SERVICE No. 924

Piper Aircraft Corporation
Vero Beach, Florida, U S A

Date September 13, 1989 S

SUBJECT: Shimmy Dampener Replacement

SKETCH "A"

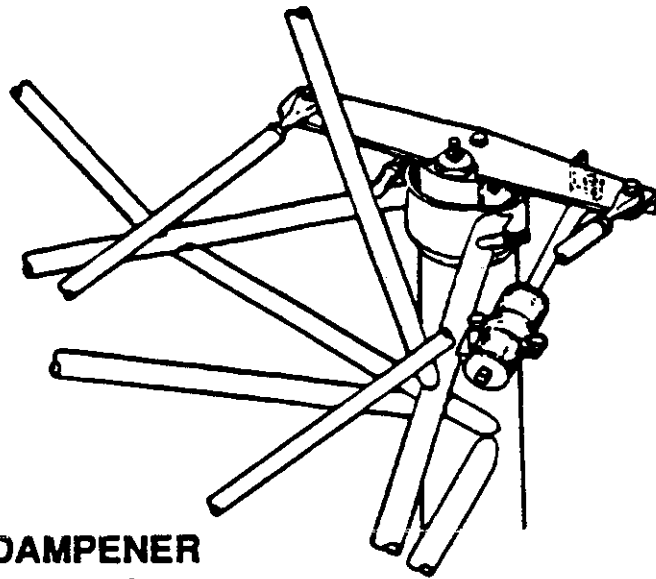
1. Remove cowling as necessary to gain access to nose wheel shimmy dampener. Refer to applicable Owners Manual or Parts Catalog.
2. Shimmy Dampeners with Piper Part Number 13086-00, as identified on Sketch A (attached), should be removed, discarded and replaced by Piper Part Number 21701-06.

This Service Bulletin recommends the shimmy dampener currently installed in the affected model aircraft be replaced by a new Shimmy Dampener, Piper Part Number 21701-06, and provides instructions for continuing maintenance at regular intervals.

SKETCH "B"

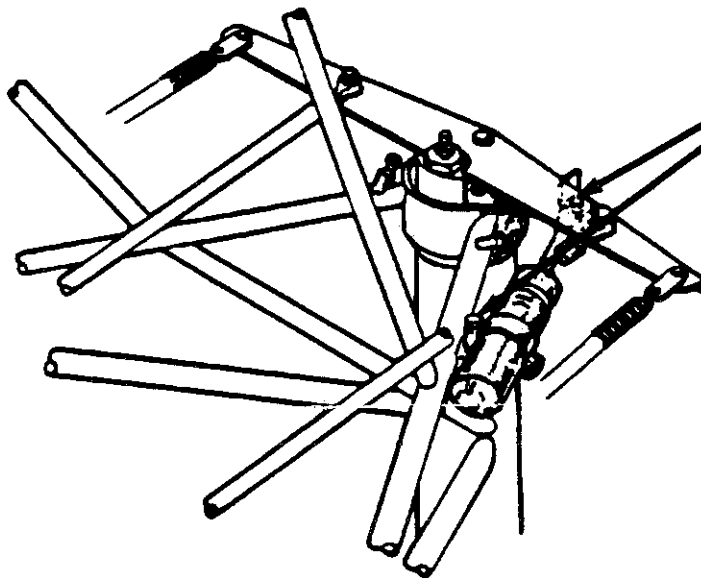
3. If the shimmy dampeners with Piper Part Numbers 21701-02 and 21701-04, Sketch B (attached), are inspected and determined to be serviceable and airworthy and the instructions below are complied with, those shimmy dampeners may be returned to service.

6. Determine that the attachment of the shimmy dampener rod end to the nose wheel steering arm is free to accept angular travel in either direction.
7. Should any stiffness, restrictions, or other maladies be noticed, correct by replacing parts and adjusting as necessary until proper fit and function is obtained.

8. A regular maintenance routine of inspection, cleaning, and lubrication should be performed at each one hundred (100) hours of operation or at any inspection event. Lubricate shimmy dampener rod end and pivot point using general purpose low temperature oil (MIL-L-7870 or equivalent). Wipe shimmy dampener shaft using a clean cloth saturated with MIL-H-5606 hydraulic fluid.
